# **SEPTEMBER 2019**

# VICKERY EXTENSION PROJECT AMENDMENT REPORT

SEPTEMBER 2019 Project No. WHC-15-33 ID: 00995972

WHITEHAVEN COAL VICKERY EXTENSION PROJECT Project General Arrangement -Project Mining Area

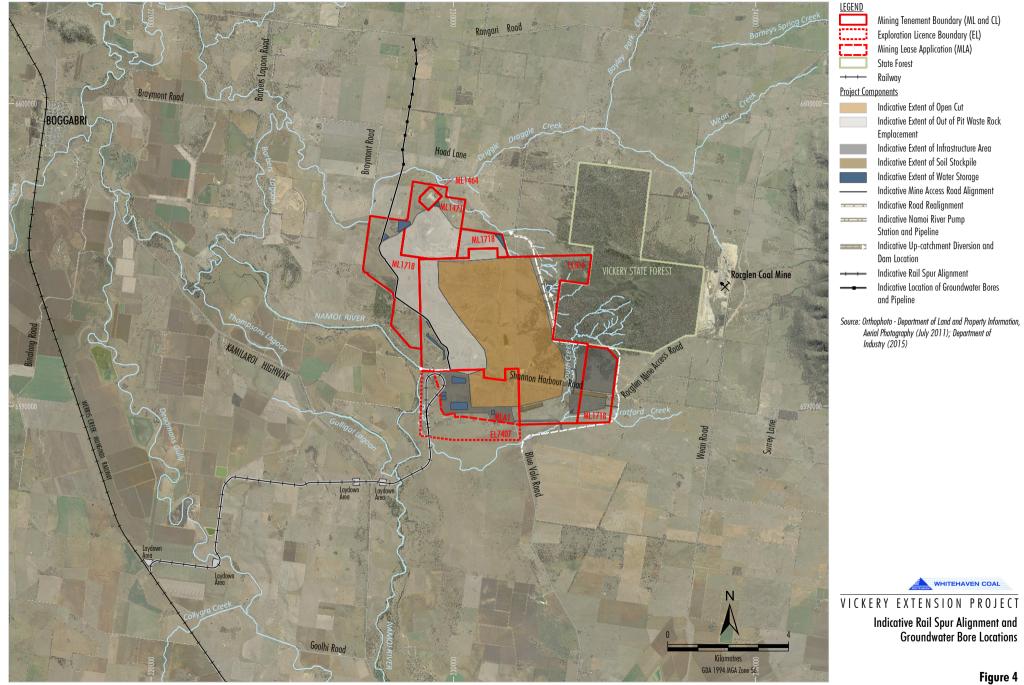
Accordingly, approximately 11 Mt of coal proposed to be extracted within ML 1718, as described in the EIS is no longer proposed to be mined as part of the Project for which development consent is currently being sought. The revised Project general arrangement, which demonstrates the revised open cut extent, is provided in Figures 3 and 4.
